SEQUOIA

OUTLINE OF NEW FEATURES

The following changes are made for the 2009 model year.

2. Package Option

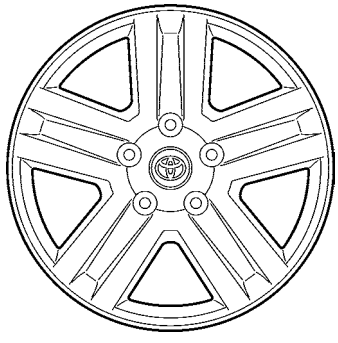
A sport package is provided for the SR5 grade.

A radiator grille in the same color as the exterior color is provided for the sport package.

A dark gray metallic 20-inch aluminum wheel, with the same design as that of the SR5 grade, is provided for the sport package.
